To replace Epia ML Motherboard with VB7009

Epia has discontinued the ML and replaced it with the VB7009.

To replace Epia M830 Motherboard with VB7009

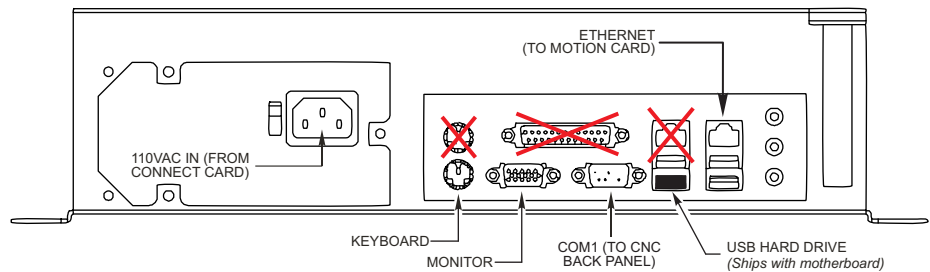
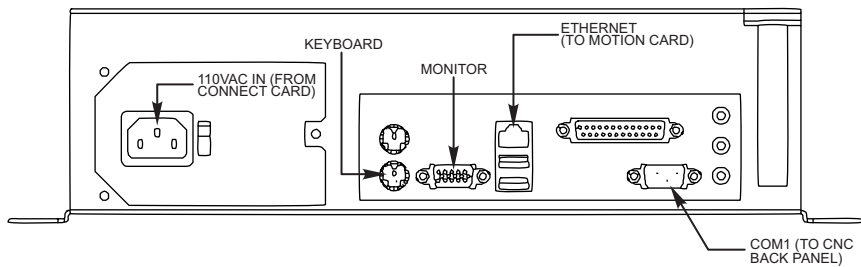
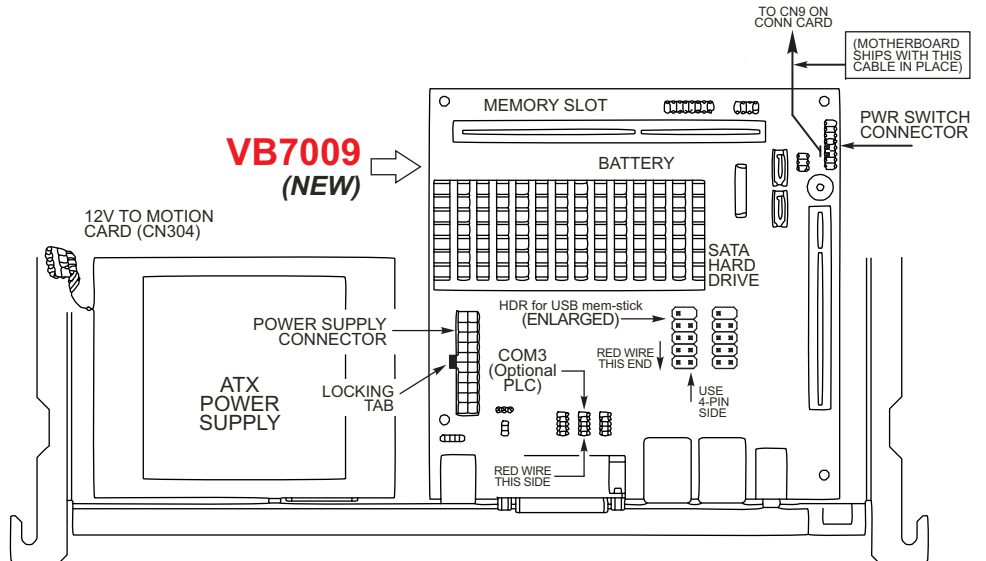
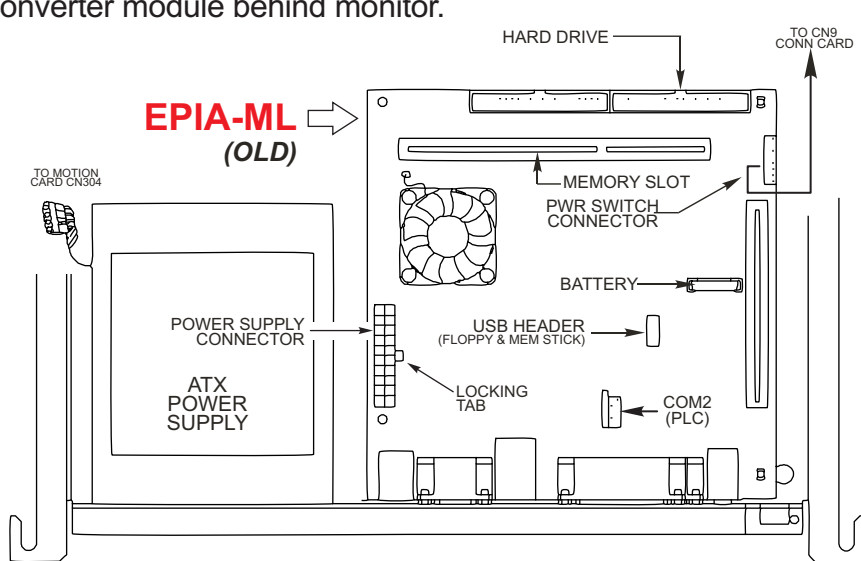
HARD DRIVE: The IDE hard drive ports have been replaced with SATA, so your existing hard drive will not work. *The VB motherboard ships with a USB hard drive pre-installed, configured for your system.*

POWER CONNECTOR: Note that the locking tab is reversed on VB.

COM2: If you have ribbon cable at COM2 (PLC) on Epia ML, you will need 2.5mm -2mm adapter. Install cable and adapter at COM3 on VB7009, red stripe toward front. Route this cable to the RS422 converter module behind monitor.

USB HEADER: If you wish to continue using floppy for backup, you must release the floppy disk while CNC boots up, then push it in to backup your program files. Probably better to use USB for backup.

PWR SWITCH CONNECTOR: Motherboard is shipped with cable connected to this header. These connections are unchanged from ML to VB, so you may wish to remove the cable at the header and use your existing cable. Otherwise, route this cable to CN9 on connect card and discard your original cable.

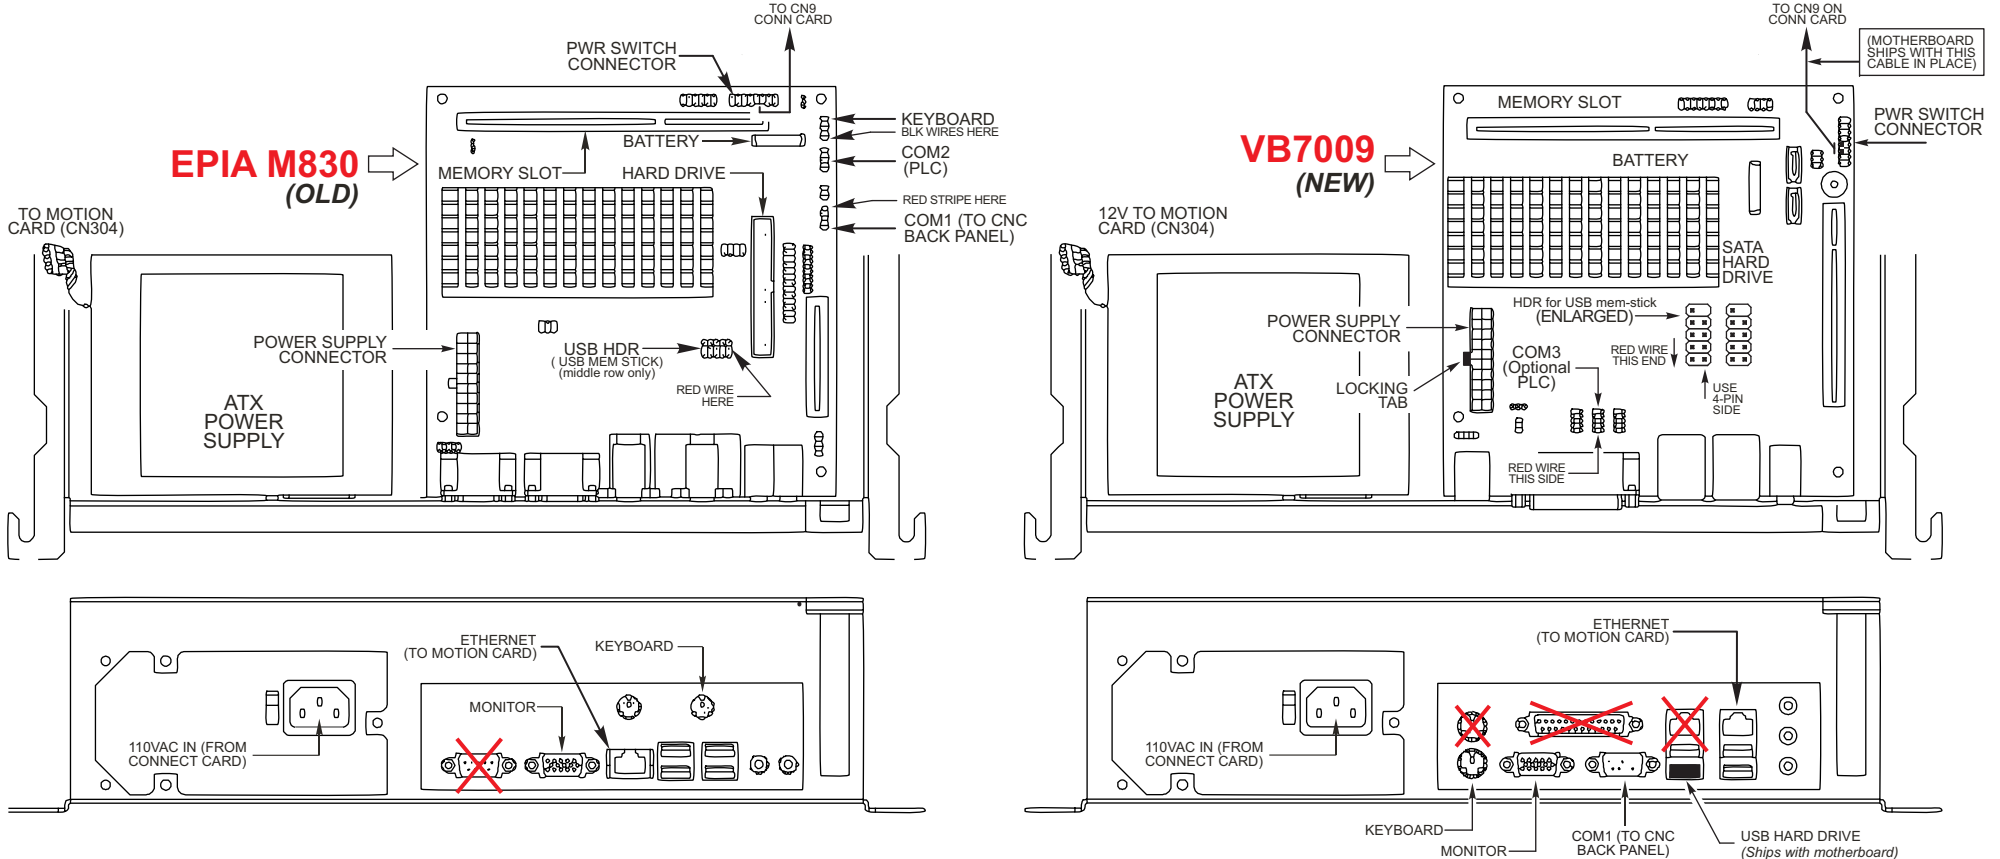
HARD DRIVE: The IDE hard drive ports have been replaced with SATA, so your existing hard drive will not work. **The VB motherboard ships with a USB hard drive pre-installed, configured for your system.**

PWR SWITCH: Moved from back to right side. Motherboard is shipped with cable connected to this header. These connections are unchanged from M830 to VB, so you may wish to remove the cable

at the header and use your existing cable. Otherwise, route this cable to CN9 on connect card and discard your original cable.

COM1: The 10-pin ribbon-cable from header on mother board must be replaced with cable provided. Connect 9-pin female to COM1 connector on computer panel; route 9-pin male to CNC rear panel.

COM2: If you have ribbon cable at COM2 (PLC) on Epia M830, move that cable, including adapter, to COM3 (PLC) on VB7009. Red stripe goes toward front.
